**NESTOR Shielding and  
Dosimetry Improvement  
Programme.**

**The ASPIS-PCA Slab  
Geometry Benchmarks.**

AEW - M 2329

CORRIGENDA TO AEEW - M 2329

Figure 6.1 MCBEND model of the NESDIP 1 array

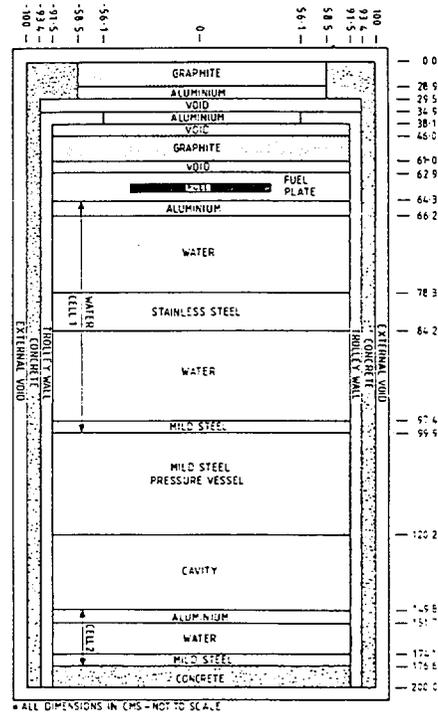
Figure 6.1 Distances from inside face of trolley front should change to  
... 66.2, 78.3, 84.6, 97.8, 100.3, 120.6, 150.2, 152.1, 174.5, 180.0, 200.0

Figure 6.2 MCBEND model of the NESDIP 2 array

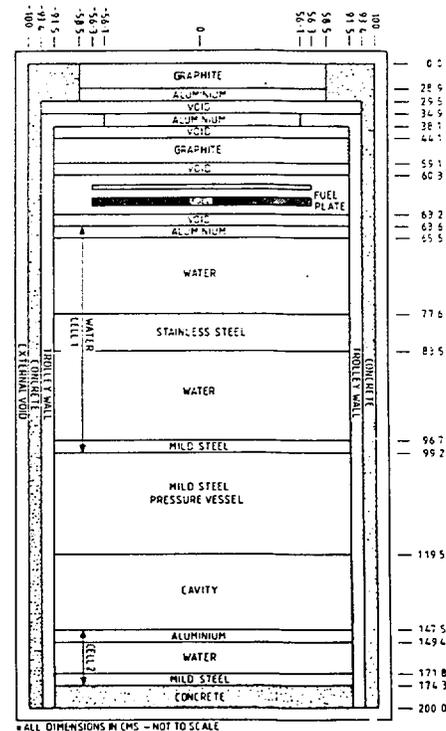
Figure 6.2 Distances from inside face of trolley front should change to  
... 65.5, 77.6, 83.9, 97.1, 99.6, 119.9, 147.9, 149.8, 172.2, 174.7, 200.0
